**Environmental Consultants**  
PO Box 489, Dunedin 9054  
New Zealand  
Tel: +64 3 477 7884  
Fax: +64 3 477 7691

**RE: ALLIANCE GROUP LIMITED – LORNEVILLE FURTHER INFORMATION REQUEST**

## **ALLIANCE GROUP LTD, LORNEVILLE PLANT:**

### **WASTEWATER IRRIGATION: MEMORANDUM TO ADDRESS LOWE ENVIRONMENTAL IMPACT REVIEW**

Soil map of Lorneville farm including the current wastewater irrigation area.

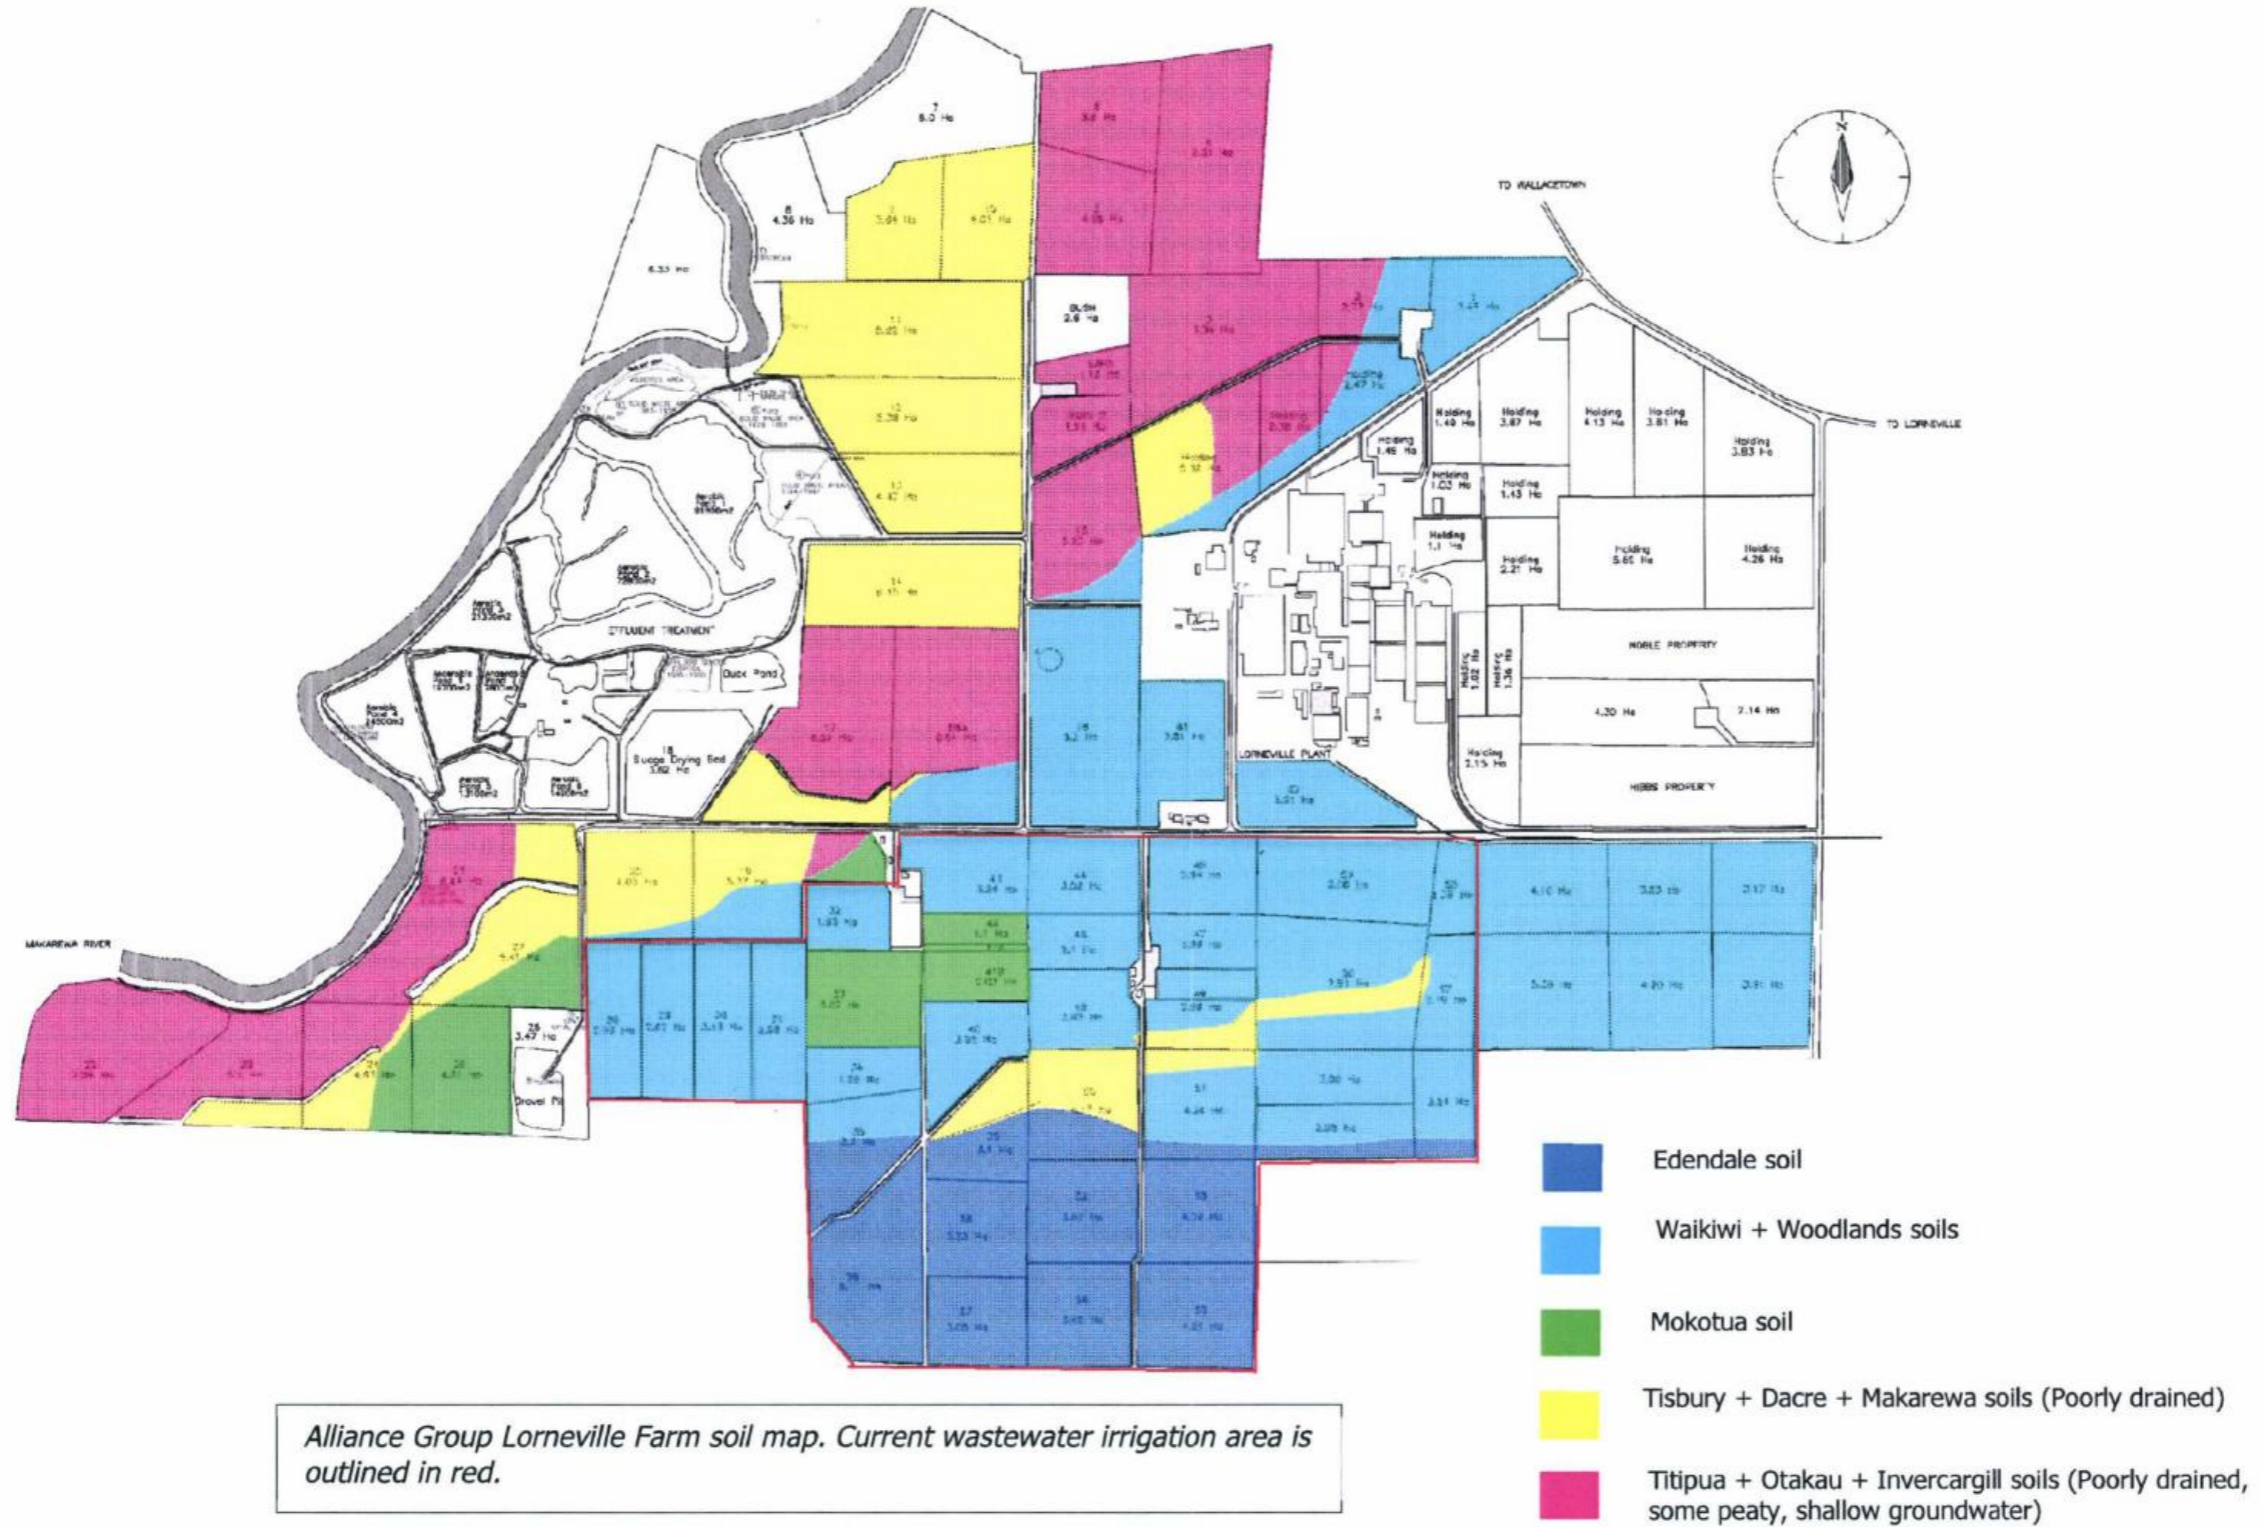
App P # 43	The hydraulic loading of 50 mm per application event (within 24 hrs) is high, resulting in forced drainage, even if the soils are less than field capacity.	can the return period be lessened with lower application depth? Nothing about PAW of the soils.	A memo has been prepared by SoilWork Limited to address this matter and is attached as Annexure 2 to this response.
App R # 44	The sludge application area shown on Drg 3 is significantly larger than the current wastewater irrigation	Provide soils information for the entire area that sludge is to be spread	The soils information is provided in the PDP Figure 1 Rev F – Alliance Lorneville Proposed Biosolids Disposal Area in Appendix J.

1. Soils within the irrigation area have recently been mapped as a part of this overall consent investigation and a summary soil map is shown in Appendix 1. The map shows that soils within the current 102.6 ha irrigation area comprise mostly Edendale silt loam, Waikiwi silt loam, Woodlands silt loam, and Mokotua silt loam. These are grouped into 'Zone 1' soils that occupy approximately 93.6 ha of the total 102.6 ha area. The irrigation area also contains a comparatively small area (9 ha) of poorly drained soils (mostly Dacre and Tisbury) that are grouped into 'Zone 2' soils. There are some minor, unmapped, areas of poorly drained Tisbury soils contained within the Zone 1 area.

It is recommended that Paddock 49 and the northern halves of Paddocks 39 and 50 are excluded from further wastewater irrigations. Together, these comprise most of the Zone 2 soils within the irrigation site. Other, much smaller, Zone 2 areas exist and these should be avoided wherever practicable.
